Hyattsville Accessibility Transition Plan

Burlington Park

Burlington Road and 46th Avenue

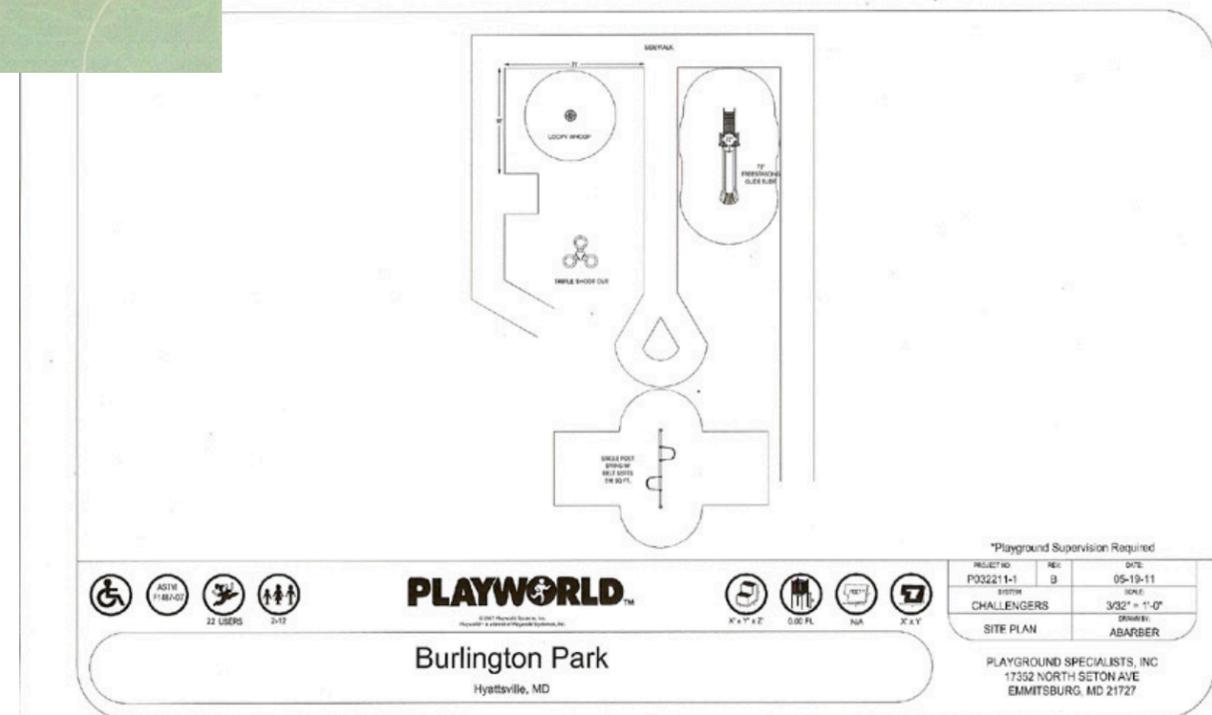
2010 Standards Citation	Description/Issue/Requirement	Non-Complying Item	Photos	Proposed Conceptual Solution	Suggested Priority	Projected Cost Hyattsville	Projected Date	Action and Date
1		Accessible Route from Sidewalks to Park Entrance:							
2	206.1, 406.2	The gutter cannot counter slope more than 5%.	The gutter to the curb ramp at the corner curb ramp at the intersection of Burlington Road and 46th Street has a counter slope of 6.6%.	2615, 2616	Repour gutter with slope no greater than 5%	15	\$750		
3	206.1, 406.1	Slope of curb ramp cannot exceed 8.33%.	The curb ramp at the entry to the park has a slope of 12.5%.	2591, 2592	Recommend removing existing curb ramp with flared sides. This ramp is not required and has no crosswalk or curb ramp on the opposite side of street.	15	\$500		
4	206.1, 406.2	The gutter cannot counter slope more than 5%.	The gutter to the curb ramp at the entry to the park has a counter slope of 7.4%.	2599, 2600	Corrected with solution for item 4	15	see item 4

5		While not a requirement of the 2010 ADA, detectable warnings are required by DOT on new construction for curb ramps in the public right of way.	The curb ramps in the right of way do not have detectable warnings.	2605, 2607, 2615	Provide detectable warnings at existing curb ramp.	25	\$500		
6		Accessible Route in Park to each Activity Area:							
7	206.1, 403.3	Accessible route cannot have a cross slope that is more than 2%.	Along the concrete walkway in the park, the sidewalk has a cross slope that ranges between 3.0% and 3.3%.	2630, 2631, 2636, 2637, 2638, 2639	Regrade and reconstruct portions of the park sidewalk with cross slopes no more than 2% and slopes no more than 5%. Move park bench adjacent to accessible route and provide wheelchair accessible seating adjacent to bench. Extend accessible route to one picnic table, pour concrete slab under picnic table with 5' x 5' extension for accessible wheelchair seating.	15	\$7,700

8	206.1, 303.4	Changes in level that are more than 1/2" require a ramp, platform lift, or elevator.	On the concrete walkway in the park, along the accessible route, there are several changes in level of more than 1/2" at the concrete joints that are not ramped.	2617, 2618, 2619, 2620, 2621, 2622, 2623, 2624, 2625	Corrected with solution for item 7	15	see item 7		
9		Drop offs, while not specifically a barrier may create an condition that is difficult for the user of an accessible route.	Drop offs on both sides of accessible path (concrete sidewalk) near tot play area are 4 3/4" high	2643, 2644, 2645	Regrade areas to each side of walkway to be flush with sidewalk surface when sidewalk is reconstructed. Corrected with item 7.	25	see item 7		
10	206.1, 302.1	Accessible route must be firm, stable, and slip resistant.	The accessible route from the walkway to the picnic table seating is not paved.	2649, 2650	Corrected with solution for item 7	25	see item 7

2010 Standards Citation	Description/Issue/Requirement	Non-Complying Item	Photos	Proposed Conceptual Solution	Suggested Priority	Projected Cost Hyattsville	Projected Date	Action and Date
11	226.1,	Seating is provided at fixed tables. At least 5% of the tables must provide accessible wheelchair spaces.	In the park, no wheelchair spaces are provided at the two tables.	2632, 2649	Provide accessible type picnic table. Also see solution for item 7	25	\$750		
12	206.1, 302.1	Accessible route must be firm, stable, and slip resistant.	The accessible route from the walkway to the bench seating is not paved	2651	Corrected with solution for item 7	25	see item 7		
13	226.1, 302.1	Benches are provided. Wheelchair spaces must be provided with the benches. The clear ground space must be stable, firm, and slip-resistant.	In the park, the wheelchair space adjacent to the bench is not paved.	2651	Corrected with solution for item 7	25	see item 7

14	205, *309.3	Controls must be within reach. A side reach is possible.	The trashcan opening is farther than 10" from the accessible route.	2652	Position trash can so that opening is no more than 10" from accessible route.	25	\$0		
15	216.3, 703.5.5	Informational and directional signage must have a character height of 5/8" minimum.	The characters on the Park Rules signage is 1/2".	2578	Replace signage	20	\$250		
16		Accessible Route to Equipment in Play Areas:							
17	206.2.17.1, 240.2.2.1	Where ground level play components are provided, at least one of each type shall be on an accessible route.	This is a playground. There are (3) three different types of ground level play experiences required to be on an accessible route. None of the ground level components are on an accessible route. The ground surface is mulch and shows deformations (see item 17 for additional description).	6852, 6853, 6854, 6855, 6856, 6857, 6858, 6859, 6860, 6861, 6862, 6863, 6864	Provide accessible surface to and around one of each type of play component. This will include an accessible route to entry and exit from slide, to and around the basketball tree, to and around the spinning pole, and to one swing at the swing set. Coverage based on an area of 1,500sf for poured in place synthetic rubber surface over new substrate.	15	\$22,500

16	*240.2.1.1, 1008.2.6.1	Ground surfaces shall comply with ASTM F 1951. Ground surfaces shall be inspected and maintained regularly and frequently to ensure continued compliance with ASTM F 1951.	The mulch shows deformations.	6852, 6853, 6854, 6855, 6856, 6857, 6858, 6859, 6860, 6861, 6862, 6863, 6864	Corrected with solution for item 17	15	see item 17		
18					Total		\$32,950		
19									
20					Priority 1 - 4:		\$0		
21					Priority 5 - 9:		\$0		
22					Priority 10 - 14:		\$0		
23					Priority 15 - 19:		\$31,450		
24					Priority 20 - 25:		\$1,500		
25					Total		\$32,950
